## RECALL NOTICE – BERETTA NEOS PISTOLS

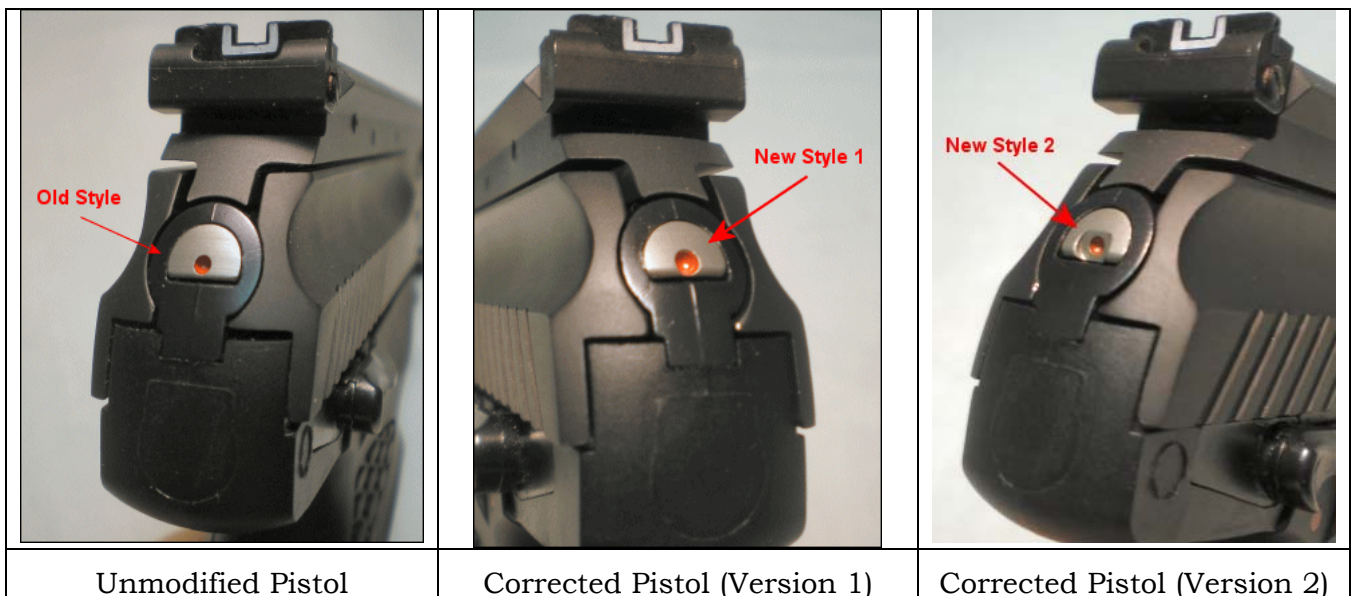
Beretta U.S.A. Corp. has discovered a potential condition with Beretta .22 caliber NEOS semiautomatic pistols in which the pistol will fire even if the safety is activated and, in some cases, the pistols may fire if the safety is moved from the OFF to the ON position. Chances of either of these situations occurring is extremely remote and no injuries have occurred because of this condition, however, because of safety concerns relating to this situation, Beretta U.S.A. Corp. is immediately implementing a recall of Beretta .22 caliber NEOS semiautomatic pistols.

Your pistol will be retrofitted, at no cost to you, with a replacement firing pin assembly. The new firing pin assembly can be identified either by a circle on the back of the firing pin that includes a red dot in the center, or by a vertical line (either version is suitable for your continued use) as seen in these illustrations:

Please make sure that your Beretta NEOS pistol is unloaded before delivery to the service center. Do not experiment with your Neos pistol to see if it has the potential safety issue. Some NEOS pistols have already been repaired. If the firing pin for your NEOS looks like Version 1 or 2 above, you do not need to return it for retrofit. Please visit [www.berettasupport.com/neos](http://www.berettasupport.com/neos) to see if your NEOS has already been repaired.
